Maura J. Rossman, M.D., Health Officer

RE: B18001636: 11725 Wayne Ridge Street, Fulton, MD 20759

Existing Use: Backyard
Proposed Use: to house collector cars
Estimated Construction Cost: \$ 70,000
Description of Work: Building a 30x40
garage Detached

REVISED

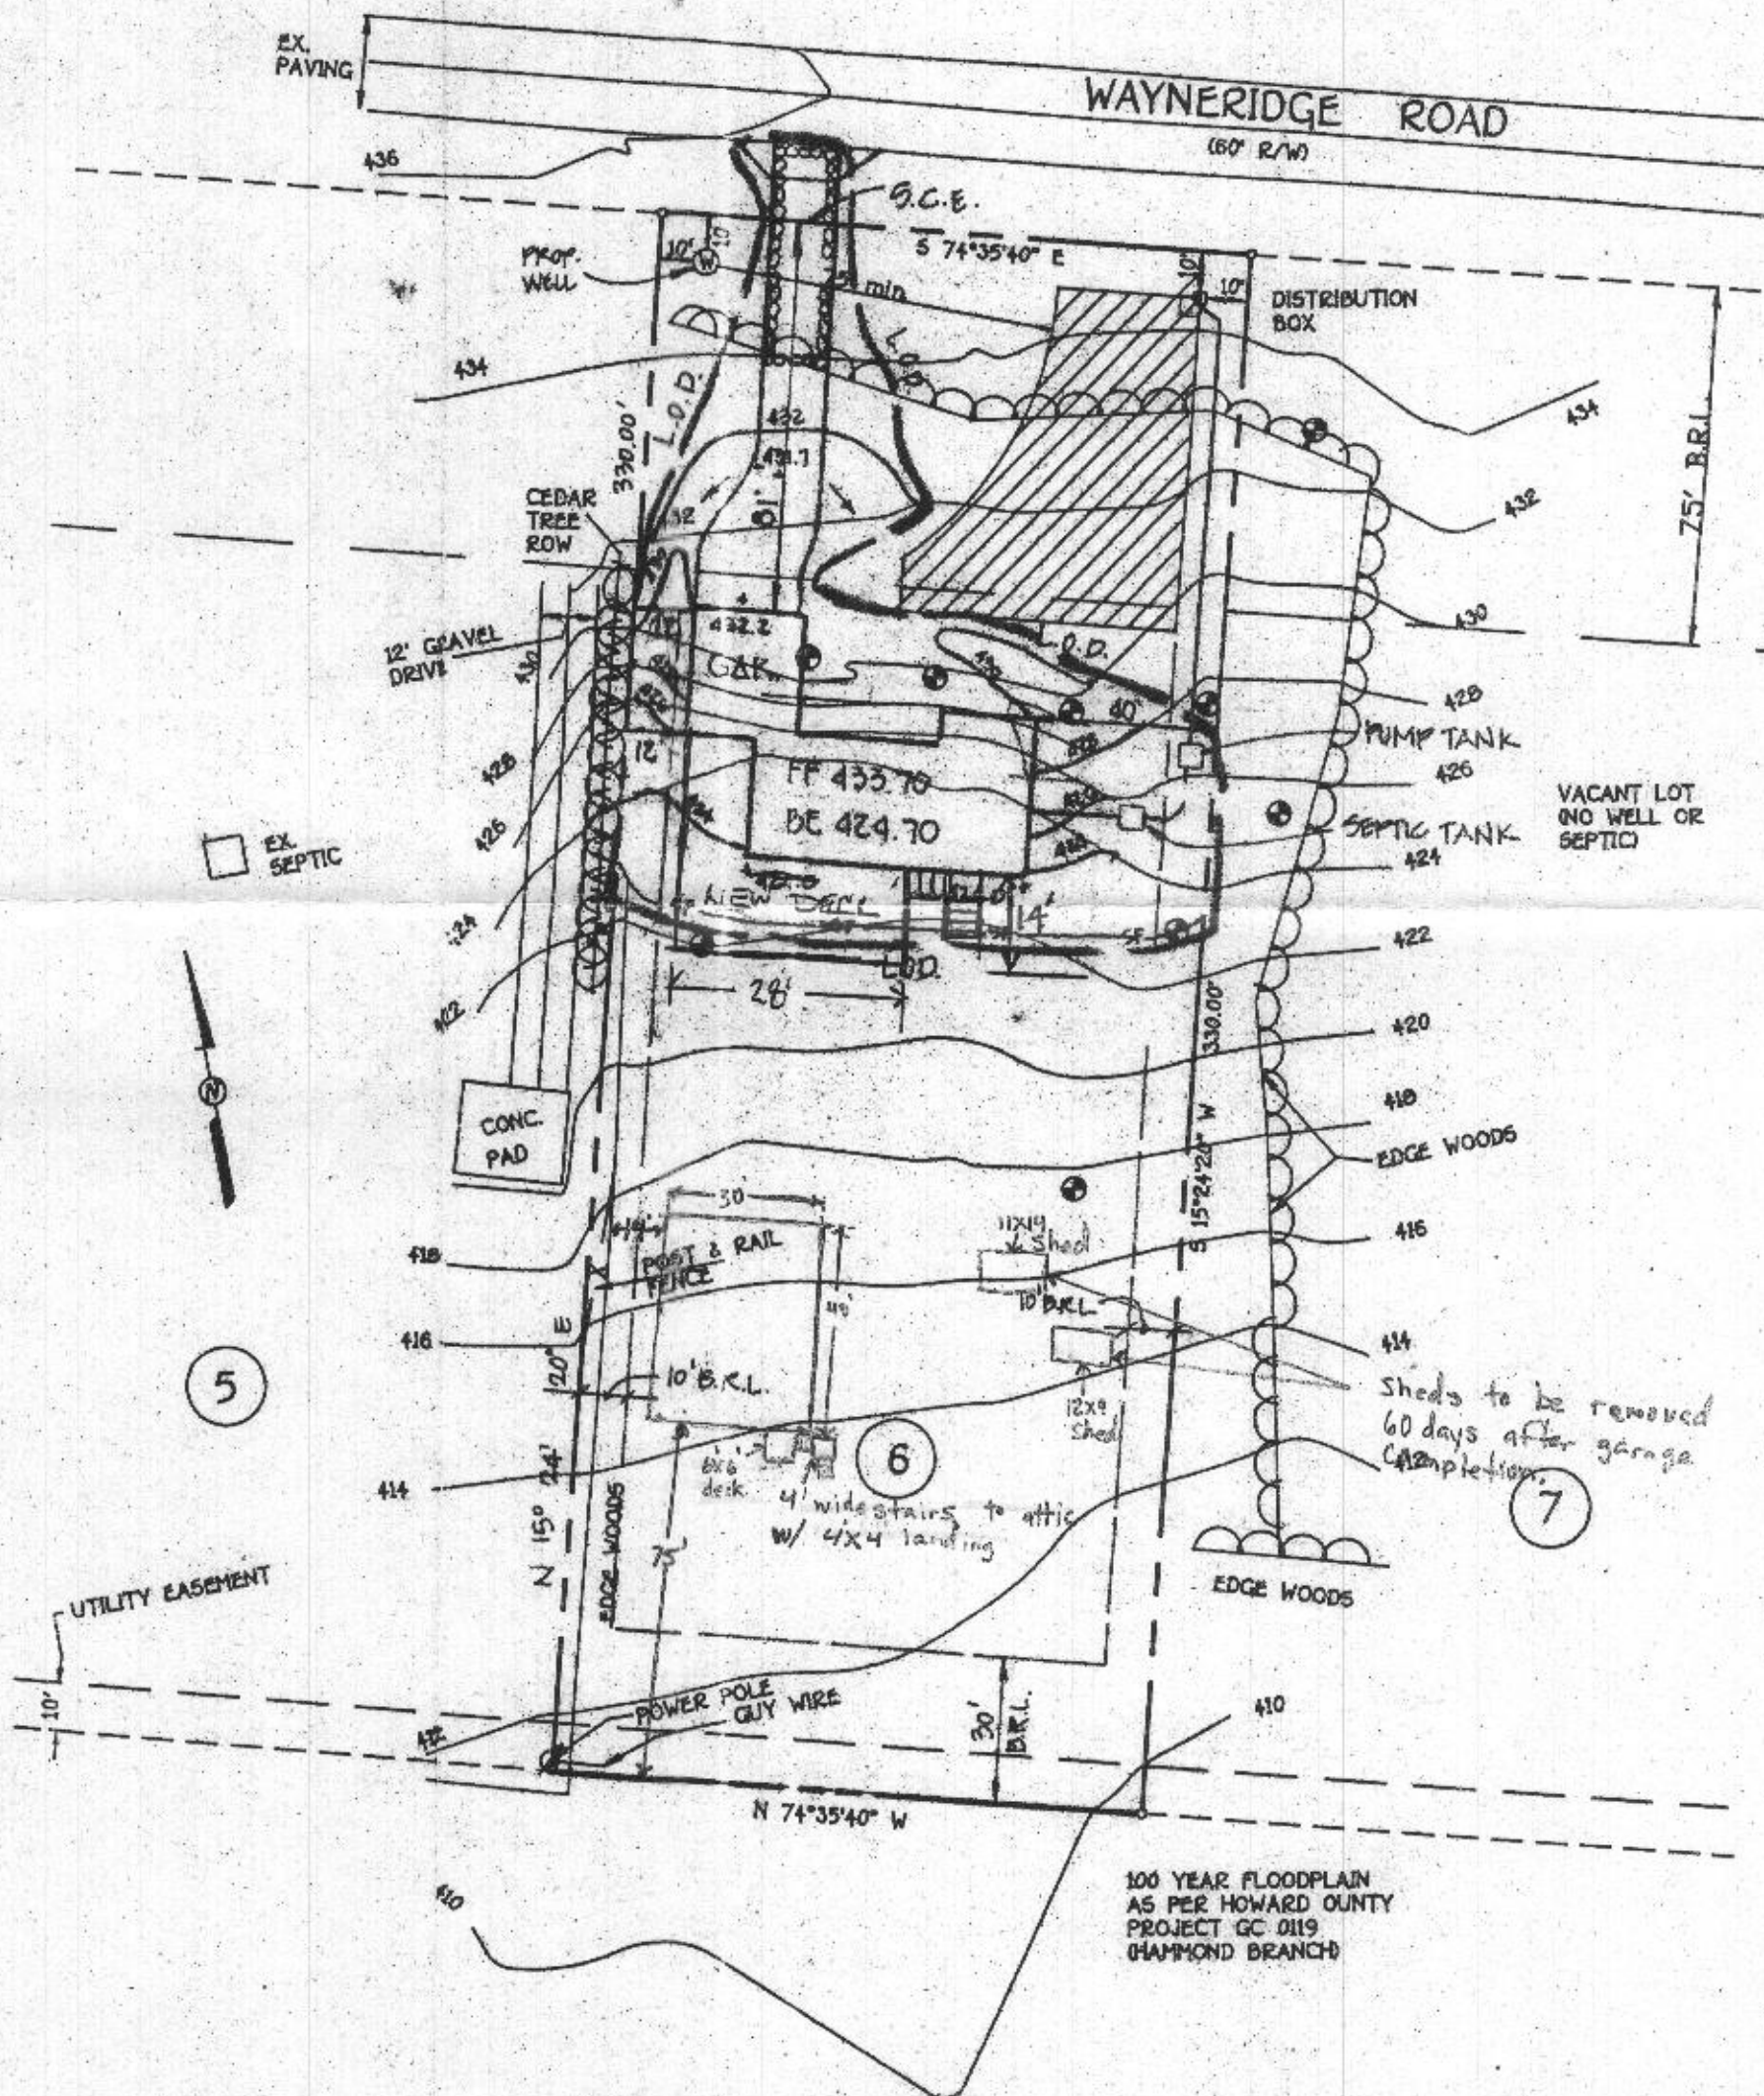
Revision DECK, LANDING,
+ STEPS SHOWN

Comments: Revised plot plan to show deck, landing, + steps
